SECY-92-131

For: The Commissioners  
From: James M. Taylor  
Exec 've Director for Operations  
Subject: REPLY TO COMMISSION'S QUESTIONS ON VOGTLE'S  
DIESEL GENERATORS AND ASSOCIATED INSTRUMENTATION

SUBJECT: POTENTIAL MALFUNCTIONS OF CALIFORNIA CONTROL COMPANY  
MODEL A3500 TEMPERATURE SENSORS

Figure 1. Schematic of a Calcon A3500 Temperature Sensor

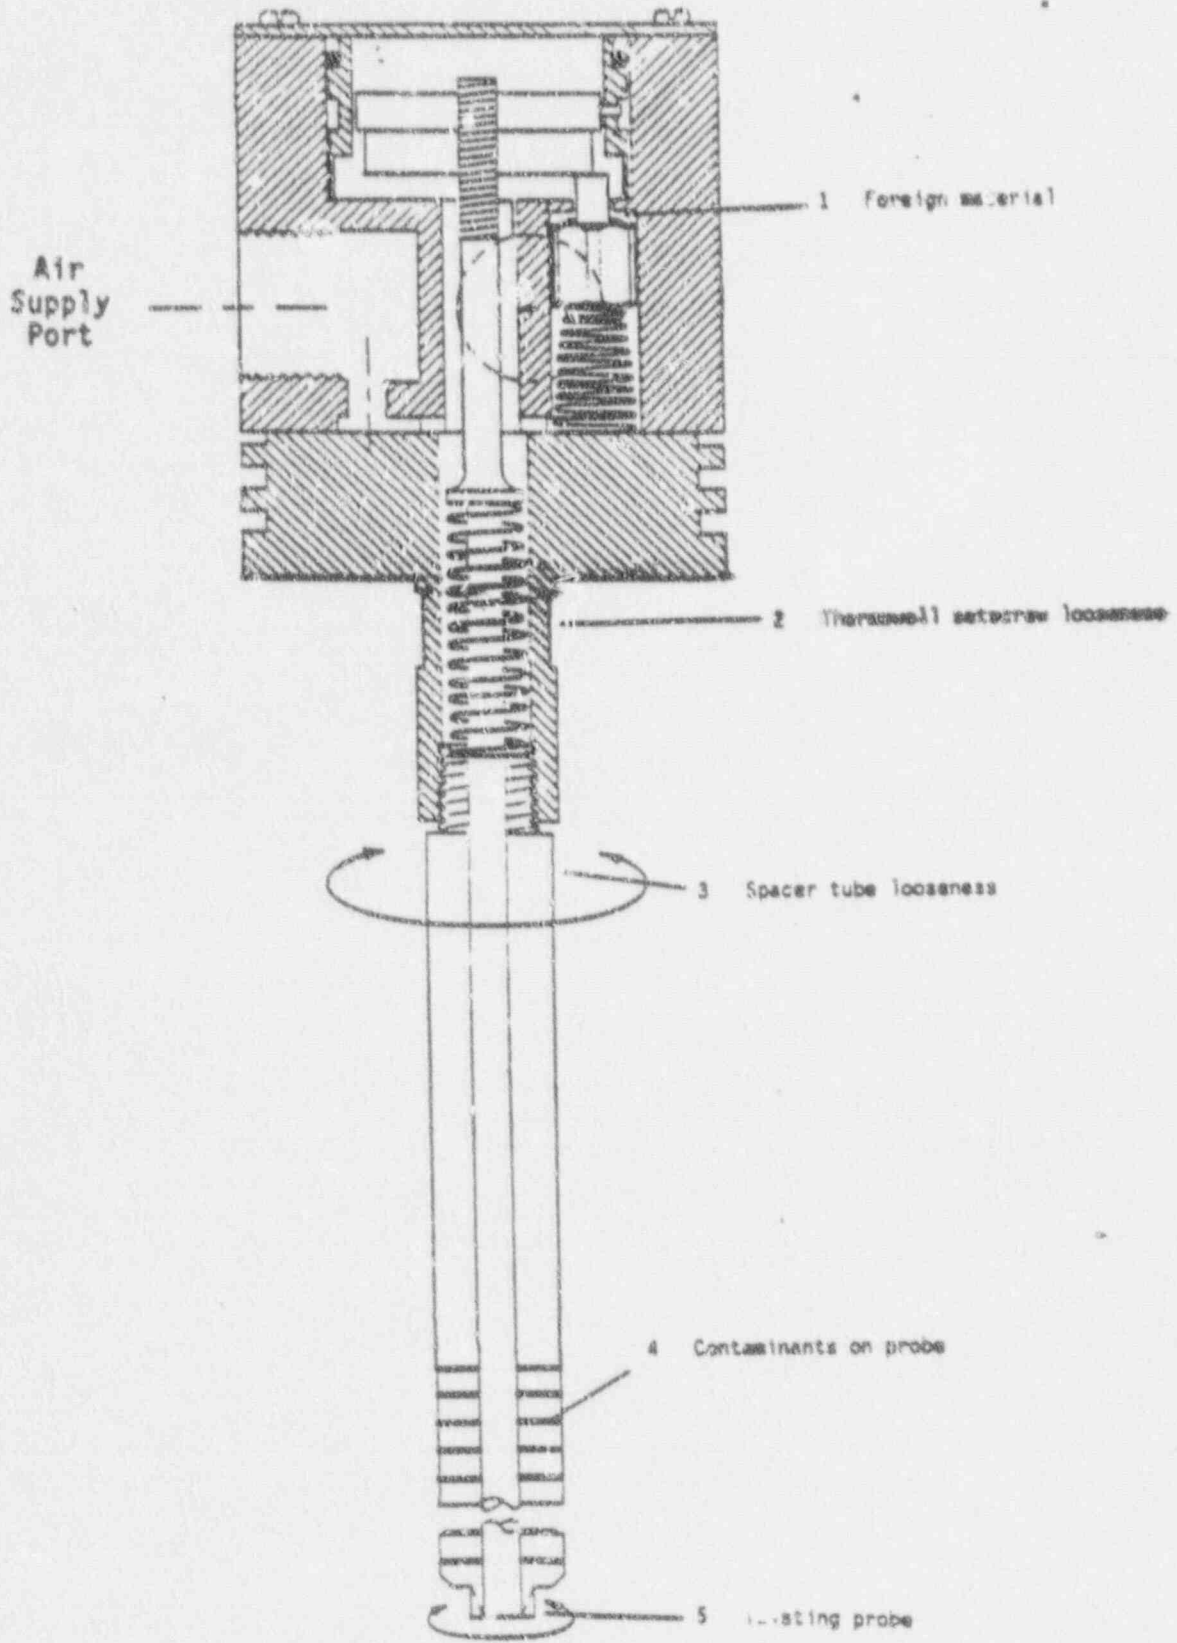
1. Foreign material in the temperature sensor - During disassembly of leaking temperature sensors, Wyle discovered thread shavings (apparently from the air supply port threads) and excess thread sealant in the poppet seat region of the temperature sensor (Item 1 in Figure 1). The foreign material can prevent an air-tight seal between the poppet seat and the poppet head orifice, and thereby cause the temperature sensor to leak air and be placed in a tripped state. After Wyle cleaned the poppet seat and the air supply port they were able to properly calibrate the affected temperature sensors.

2. Thermowell setscrew tightness - The temperature sensor is secured in its thermowell with a setscrew (Item 2 in Figure 1). Wyle performed calibration checks with the setscrew loosened, and observed a 2°F increase in the trip temperature. This change is apparently caused by the resulting loss of hard contact between the temperature sensor and the thermowell, which decreases the heat transfer rate from the bath to the temperature sensor, and thereby delays the temperature sensor response to changing water temperatures.

3. Spacer tube position - The spacer tube is located between the probe and the body of the temperature sensor, and screws into the base of the temperature sensor body (Item 3 in Figure 1). Wyle tested the setpoint sensitivity to the looseness of the spacer tube and determined that the temperature sensor setpoint decreases approximately 80°F for each full turn that the spacer tube is loosened.

5. Handling of the temperature sensor probe - Twisting the temperature sensor probe (Item 5 in Figure 1) can affect the temperature sensor setpoint in much the same manner as turning the calibration disk the same number of turns in the opposite direction.

Wyle and Calcon recommend that licensees avoid the use of excessive thread sealant on the air supply swage-lock fitting, and that the temperature sensor threads in the air supply inlet be cleaned and deburred before installing the swage-lock fitting into the air supply port.

Wyle recommends performing calibrations with the thermowell setscrew tightened.

Wyle and Calcon recommend applying a thread-locking compound to the spacer tube threads to ensure that the spacer tube remains in its tightened position during for all calibrations, tests, and in-service use.

Calcon recommends that the temperature sensor be transported to and from the EDG in a thermowell, and not be removed from the thermowell except when necessary.
